Date: 23 May 2024  
Contact: Nathan GRIFFEY  
Location: City Development  
Telephone: 07 5582 8866  
Your reference:  
Our reference: MCU/2023/15

**Further advice – Assessment Manager**

Street address: 239 Boundary Street, COOLANGATTA QLD 4225  
Real property description: Lot 6 RP1777, Lot 7 RP1777

**Figure 2: Annotated Elevation**

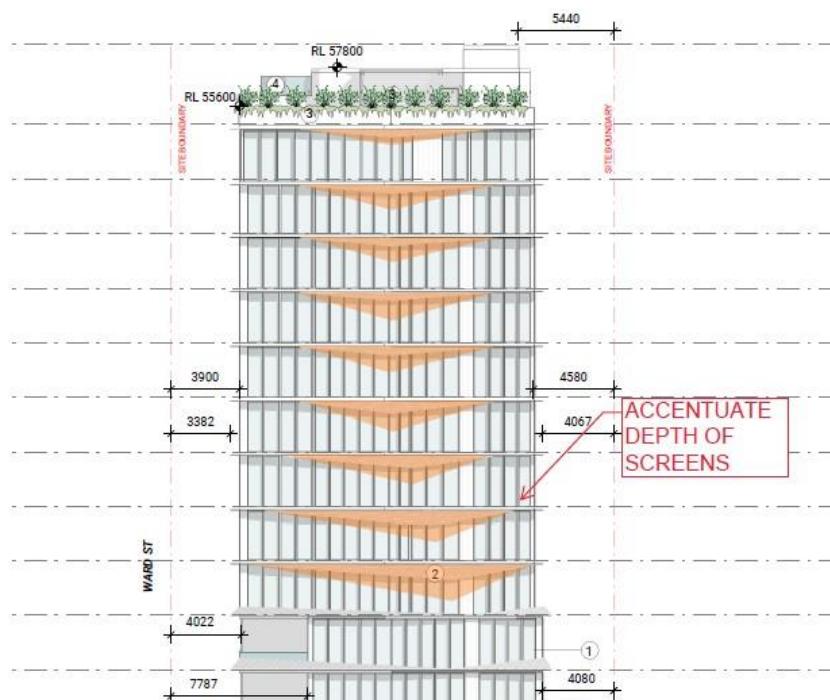
- f To further assist with the reduction in the extent of sheer glazing, noting that building recesses are unlikely to be achievable due to the tight floor plates, officers recommend emphasising the batten feature screen to the south-east elevation and shading feature to the north-west elevation, for movement, shadow play and visual interest. This may be achieved by accentuating the depth of the vertical point as it moves across the façade at each floor level as per the mark up below.

### 2 Ward Street frontage

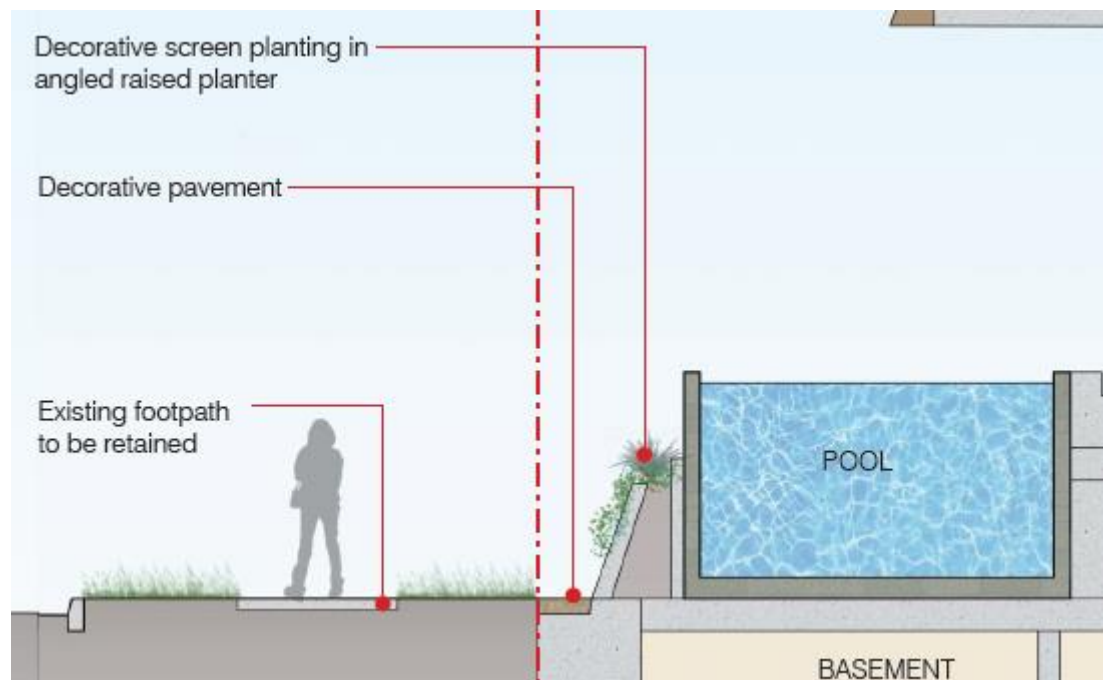
The applicant has provided amendments to the frontage landscaping beds to provide a consolidated planting area. Officers note that the decorative paving on the south western boundary adjacent the pool results in a planter width pinch-point of less than 400mm (below image). The applicant is requested to adjust the angle of the angled raised planter to provide a wider planting surface area with a minimum width of 400mm excluding the planter box walls.
